TODDBROOK SPILLWAY FAILURE

**Review of the reports into the failure and damage to the
dam on July 31st. 2019**

Graham Aldred.

24/2/2021

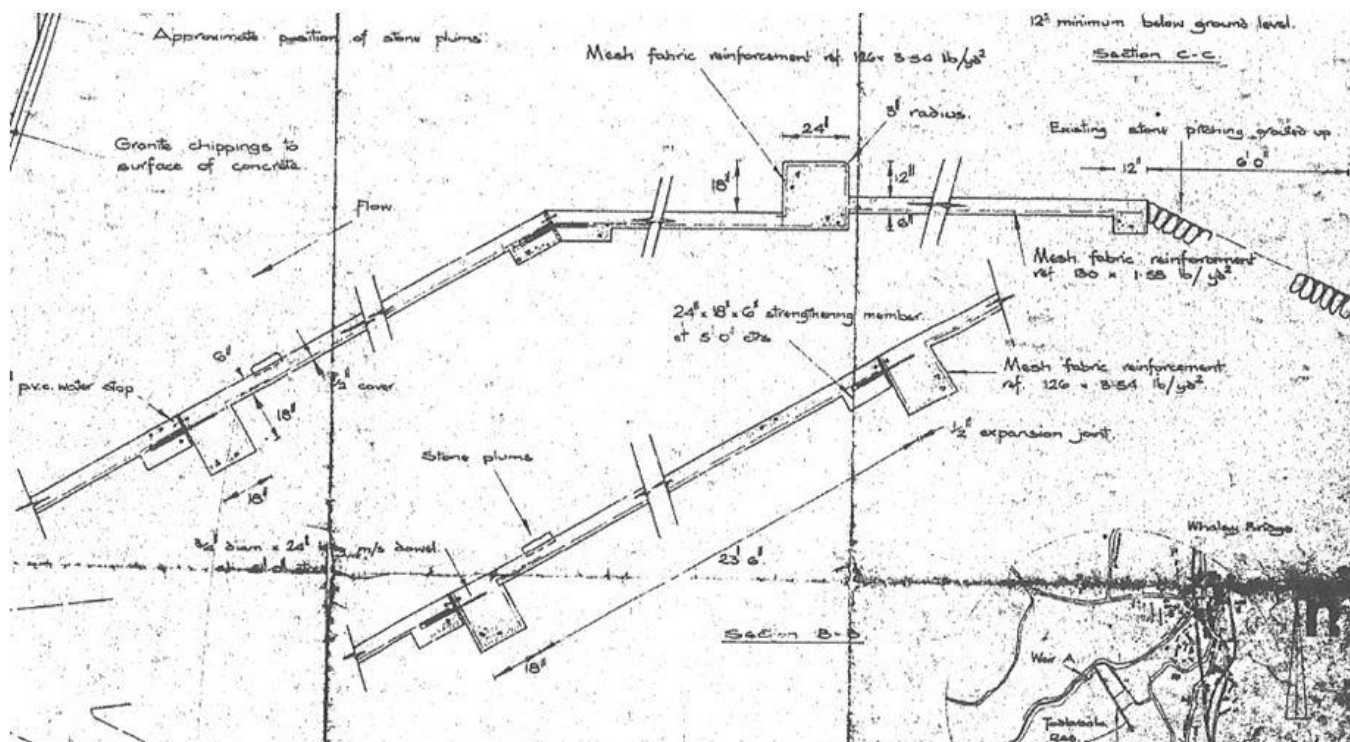
Fig 1. This poor incomplete drawing suggests how the auxiliary spillway was supposed to be constructed. It is hard to believe that this was the only specification of such a major destructive project to a Dam. It lacks numerous details defining the Apron. It would be expected that the BW Archive of Documents which the CRT inherited should have many other relevant documents including, Design Approval and especially a Risk Assessment. This is the drawing being referenced when it was claimed by the Inspecting Engineer (in 1970) that:-

This drawing initiated the reckless destruction of an otherwise safe earth clay dam in 1970. This was a modification that has subsequently caused a continuous catalogue of failures and defects on the dam from the outset and which led directly and irrevocably to the near catastrophe in Aug 2019.

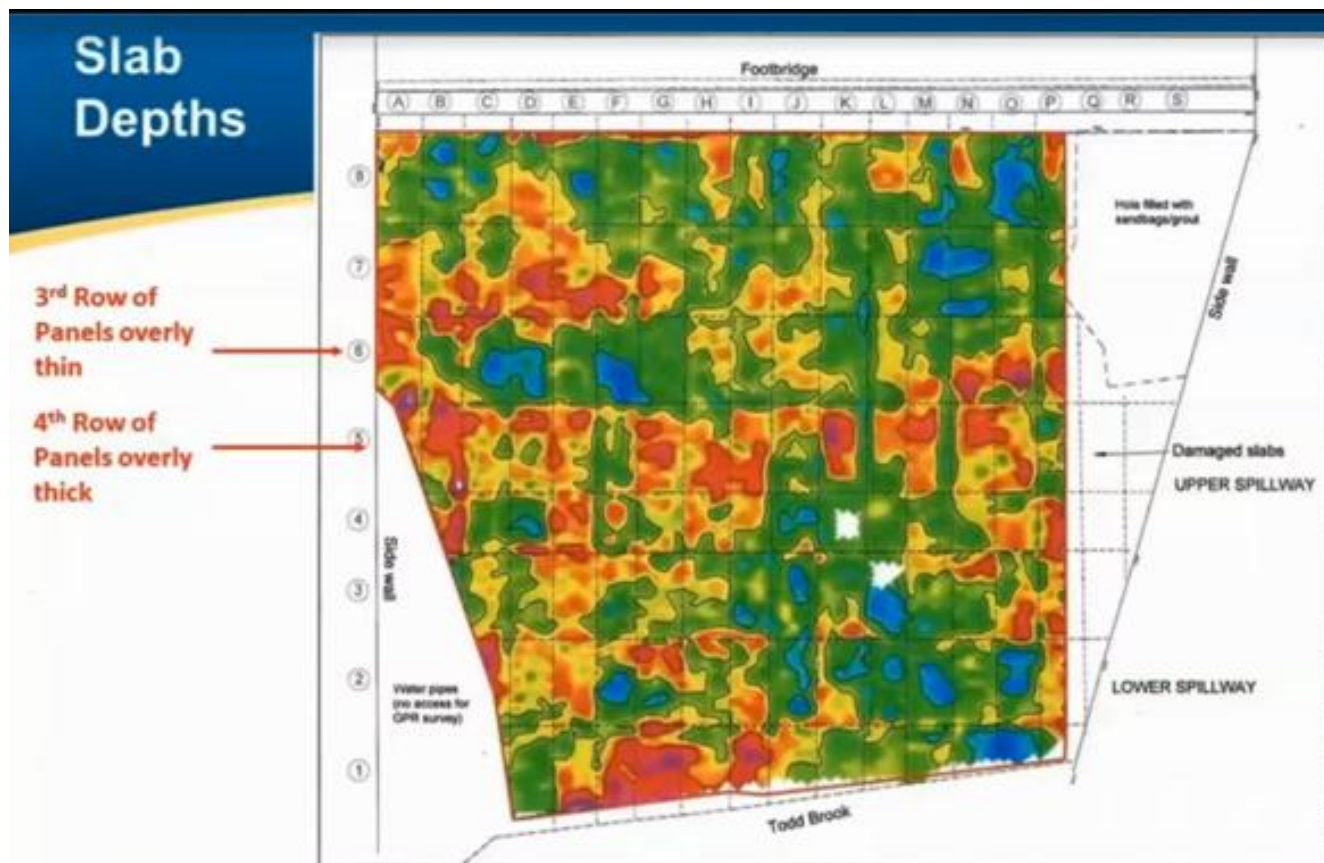
The image below shows a GPR survey of the varied concrete thickness of the panels that were accessible after the incident (*Peter Mason, July Seminar.*) It covers a range from Green/blue thin, about 70mm, (3in.) to red/orange, thick around 200mm (8in.) This image confirms the huge difficulties of laying slabs manually on a 26 deg slope. It confirms the predominant thinness of the top two rows. These panels, without proper reinforcement, were as brittle as wafer biscuits for their size, many of them had parts only 3in. thick with little or no chance that a waterbar would be embedded and therefore would leak.

Blue, green and light yellow mean that the concrete is thinner than the required 6 inches.

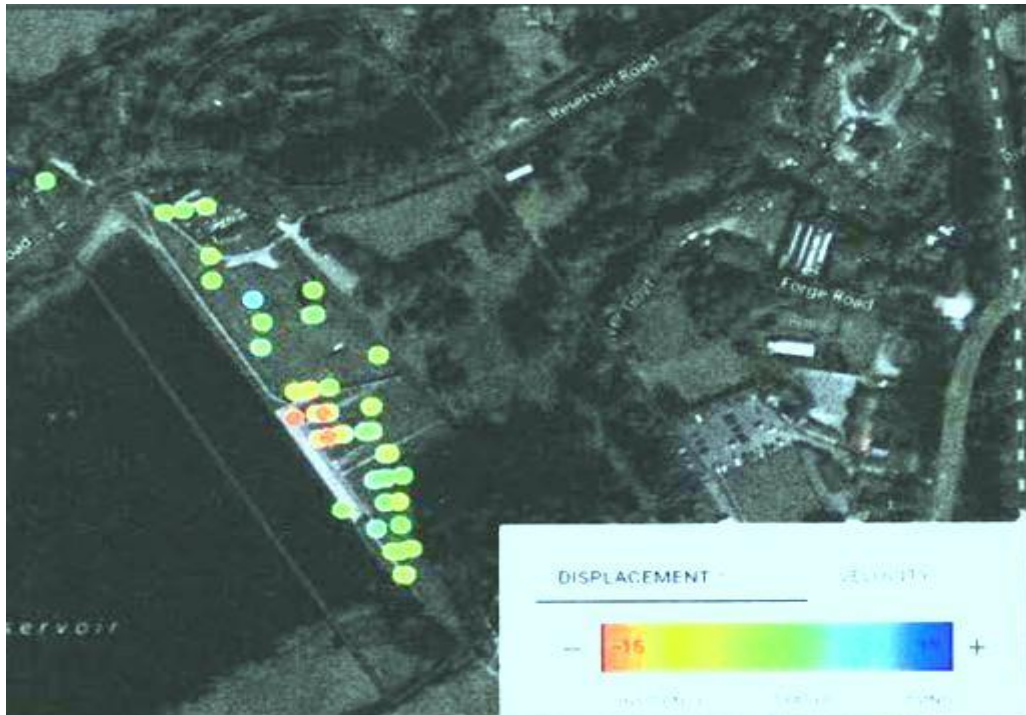
Even though the Dam is 180 years old it can continue to settle for various reasons. There are 23 survey pins located in various places on the downstream face of the earth dam and possibly 12 more on the concrete spillway of which only 9 are monitored occasionally (AH/20). As the dam settles the new position of the pins can be detected on a surveying instrument and then plotted. These measurements are absolutely fundamental for the assessment of safety and stability of the dam and are an essential part of maintenance of the Dam. But this data shows that both British Waterways and then CRT have failed to do this consistently. Pins have disappeared or are ignored especially on the spillway.

The plot below shows the changes for the last 20 years. If all the pins indicate the same small downwards movement there may be less reason for alarm. It is the differences in individual Pin behaviour that should demand prompt investigation and explanation because this could provide an early warning of differential movement and instability of the dam.

Looking downstream, the group of pins in the middle, SO1-9, are on the Auxiliary Spillway. For some reason their records only start in 2010 and have only been read **3 times** since then. Pins SP1 to SP15 are on the LH side where the damage occurred, with up to **9 records** from year 2000. Pins SP16 to SP23 are on the RH side.

SP15 which is adjacent to the LH abutment wall has dropped 30 mm in 19 years, SP 16 at the RH side is nearly as bad. This strongly suggests greater local slump due to erosion channels exploiting the cross dam trench dug for the construction of the abutment walls. This is almost certainly a critical cause of the damage, evidence that has been available for **10 years** but not physically investigated (on both sides of the abutment wall), despite extensive cracking of the Apron there. All the other pin variations demand an explanation especially SP04 (which is behind the sailing clubhouse), it has dropped 80mm since 2001. SP1 to 3 are never read for some reason even though they are on the dam embankment, critically near the Bypass channel.

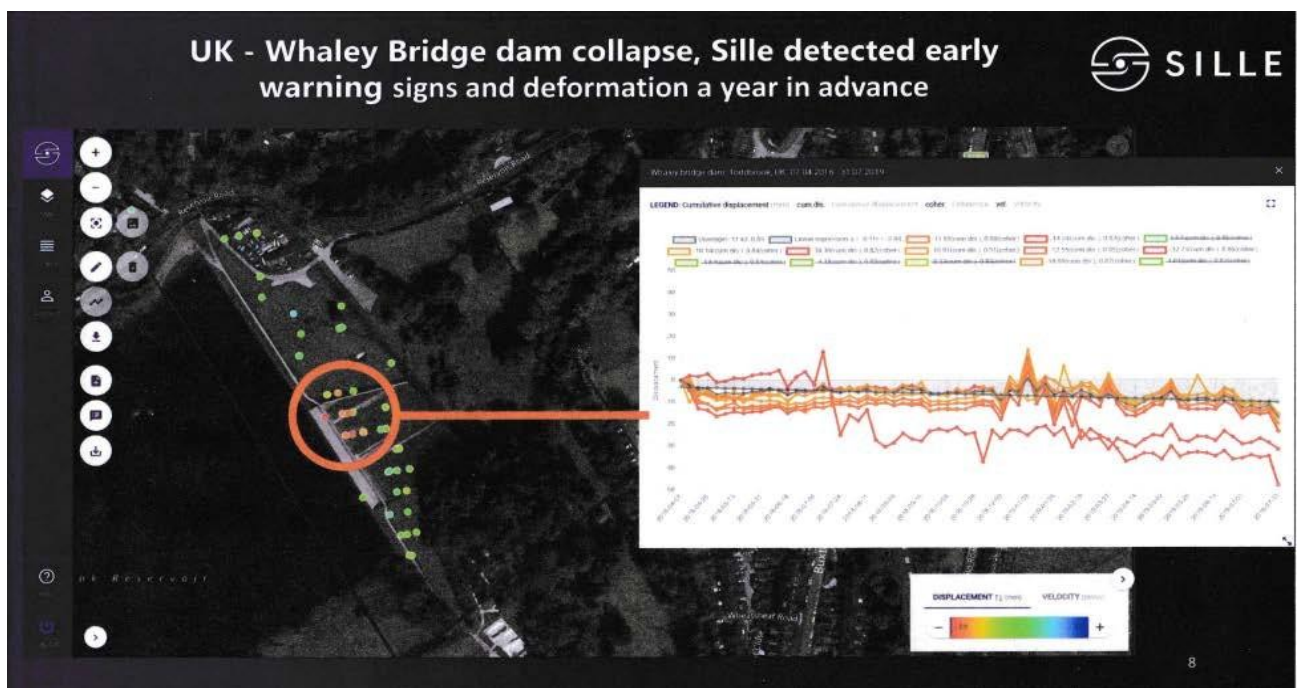
Copernicus Satellite surveillance has been used to duplicate terrestrial surveys of the pins (AH/45). (taken before the damage event.) The location of the pins on the dam is shown on this satellite picture. The yellow and red pins have all moved noticeably in the LH corner where the damage was to occur in future.

The fuzzy graph (screen photo) shows that most pins are behaving roughly the same as each other but two pins have dropped (ie parts of the dam dropped) in July 2018 and Jan 2019 by 30 mm, both on the LH side of the spillway. This indicates that there were significant drops in the dam structure 11 and 7 months before the Aug 2019 so there was a warning a year in advance of deformation which was not heeded by, at least, drawdown. This raises some questions:- What caused the Toddbrook Dam to be monitored by satellite for over a year ? Who requested it? Was the CRT aware of these drops ? Was dam survey pin data given the attention it merited?

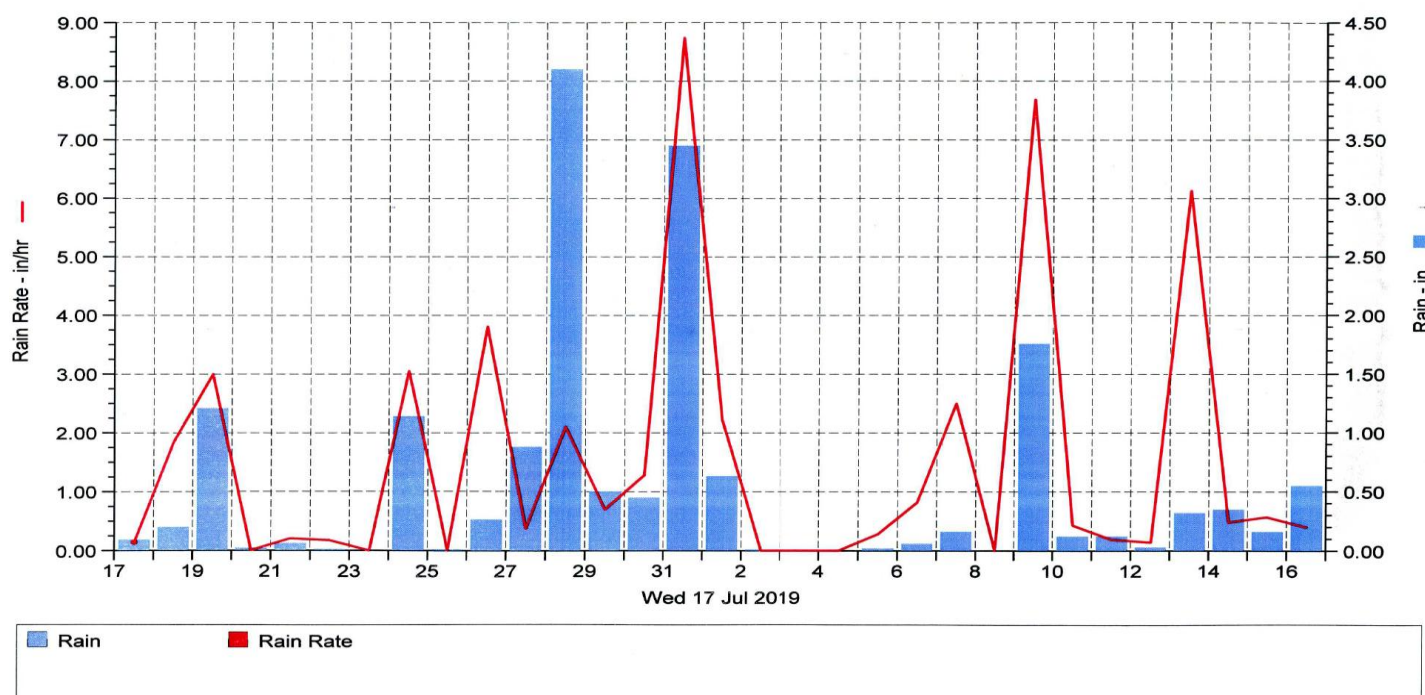
Fig. 1 Local Record showing the 2 rain events on 28th and 31st July. Note the 7 virtually rain free days that immediately followed the collapse and allowed the reservoir to be slowly drawn down and thus saved Whaley Bridge. (I have permission to use these records of a local climatologist who lives just north of the catchment.)

As the records in Fig. 1 show, starting on Saturday evening there was about 36 hours of continuous very heavy rain, a total of 130 mm was recorded with the majority, 104 mm. on Sunday 28th. It was this monsoon (plus a further 25 mm of rain in the next two days) that arrived progressively from the catchment area and amplified and maintained the massive unprecedented auxiliary spillway flow.
